# Minutes: SPECIAL Plumbing Board meeting

## Ad Hoc Code Review and Rulemaking Committee 2018 UPC Recommendations to the Board

# Plastic DWV and storm pipe expansion table Attachment B Exhibit B

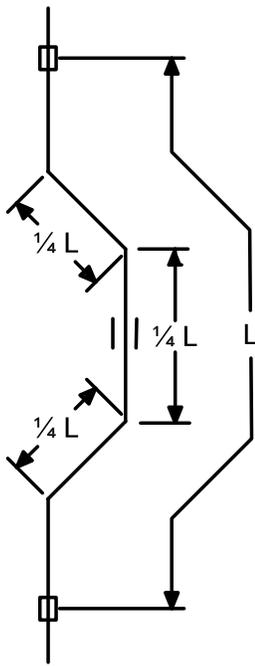
Proposed language adds clarify that vent ports must not be located such that the vent is submerged when flowing ½ to highest flow level. Blockage may occurred over times if submerged or during back-ups of the drainage system. This proposed amendment is not a significant change but rather adds clarify to the current requirement that an interceptor must be “properly vented”

**1009.4 Relief Vent.** Interceptors (clarifiers) shall be so designed that they will not become air-bound where closed covers are used. Each interceptors (clarifiers) shall be properly vented. Interceptor (clarifier) and neutralization tank vent ports must be located above the highest liquid flow level.

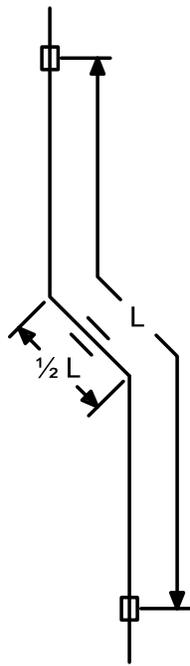
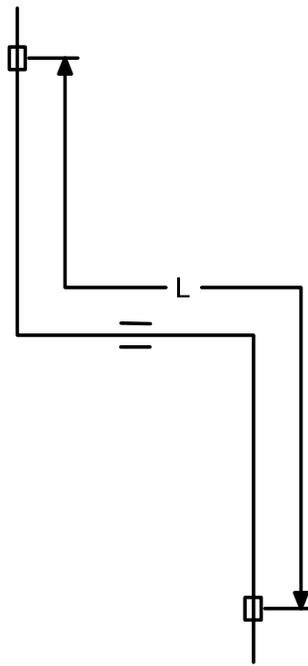
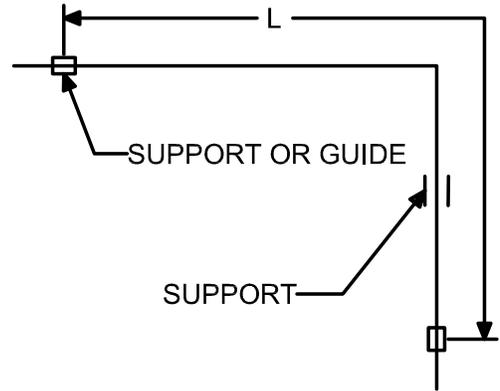
13.	N/A	N/A	Committee	312 and 313	Pipe expansion	<b>Proposal:</b> Becker to make tables to address ΔT 50 (conditioned space) and ΔT 100 (unconditioned space).  <b>Recommendation:</b> Use proposed Table 313.3.1 as modified	8/29/19, 6/17/19	8/29/2019: Becker submitted <b>Exhibit A</b> and Jim Peterson and Zach Barnaal submitted <b>Exhibits B and C</b> on behalf of DLI. <ul style="list-style-type: none"> <li>The Board agreed to accept Exhibit B with modifications. Modifications are shown on attached Exhibit B2.</li> <li>Add a footnote #6 to Table 313.3, at line "Schedule 40 PVC and ABS DWV" under column "Horizontal": For expansion loops, see Table 313.3.1</li> </ul>	8/29/19: Accept with modifications as noted on <b>Exhibit B.1</b> . Modifications accepted with addition of 10 and 20 feet – See <b>Exhibit B.2</b>

Line #	PB #	RFARFI	Submitter	Rules affected	Brief Title	Proposal and Committee recommendation	Date reviewed by PB	PB action	(A)cept (R)eject (M)odify
								<ul style="list-style-type: none"> <li>Table title change: <u>Schedule 40 PVC and ABS DWV and Storm Pipe Expansion Table</u></li> </ul> <p>6/17/19 Discussion: Installation shall compensate for thermal expansion and contraction. Expansion joints shall be utilized in vertical straight runs in excess of thirty (30) feet (9,144 mm) provided they are installed per manufacturer's installation instructions. Except piping buried below ground, horizontal and vertical piping must be installed with restraint fittings or a minimum twenty-four (24) inches (610 mm) 45 degree offset every thirty (30) feet (9144 mm) Becker said he would revise the tables to incorporate formulas for ABS and PVC and bring back to the Board at a later date.</p>	6/17/19: Modify

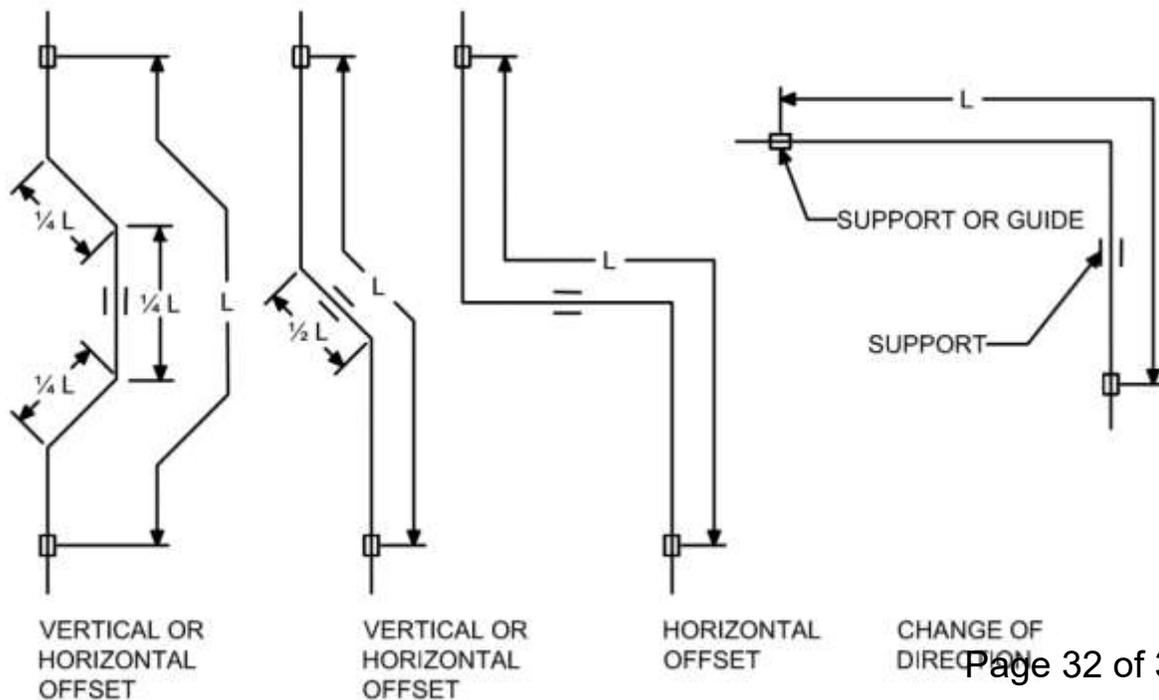
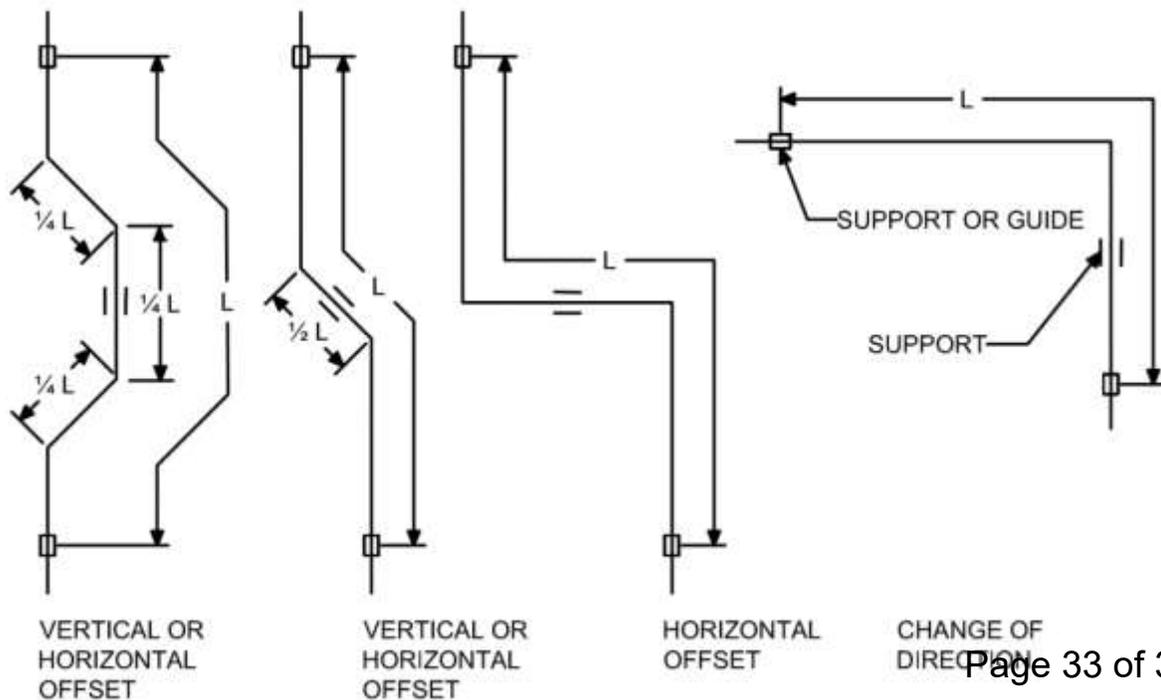
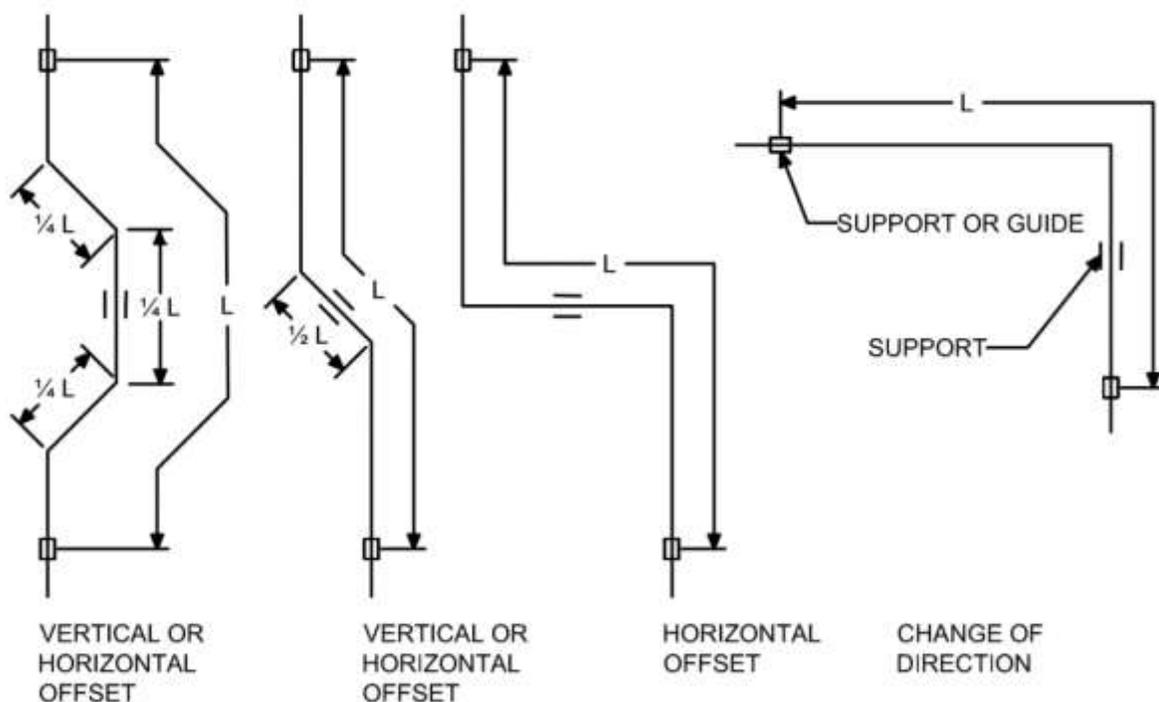
Length of Run $L_o$ (ft.) =		10	20	30	40	50	60	70	80	90	100
Pipe Size	Expansion loop length = L (in.)										
1.5"		44	51	57	63	68	72	77	81		
2"	Add numbers	50	57	64	70	76	81	86	90		
3"	from Zach	60	69	78	85	92	98	104	109		
4"	for 10 and	68	79	88	96	104	111	118	124		
6"	20	83	95	107	117	126	135	143	150		
8"		94	109	121	133	144	154	163	172		
10"		105	121	136	148	160	171	182	192		
12"		114	132	148	162	175	187	198	209

<b>TABLE 313.3.1 SCHEDULE 40 PVC AND ABS</b>			
<b>DWV AND STORM PIPE EXPANSION TABLE</b>			
Inside the building thermal envelope			
Pipe Size	Length of Run (ft.)		
	10	20	30
Pipe Size	Expansion loop length (in.) = L		
1.5"	20	28	34
2"	22	31	38
3"	27	38	46
4"	30	43	52
6"	37	52	63
8"	42	59	72
10"	47	66	80
12"	51	72	88
Outside the building thermal envelope			
Pipe Size	Length of Run (ft.)		
	10	20	30
Pipe Size	Expansion loop length (in.) = L		
1.5"	26	36	44
2"	29	41	50
3"	35	49	60
4"	40	56	68
6"	48	68	83
8"	55	77	94
10"	61	86	105
12"	66	94	114
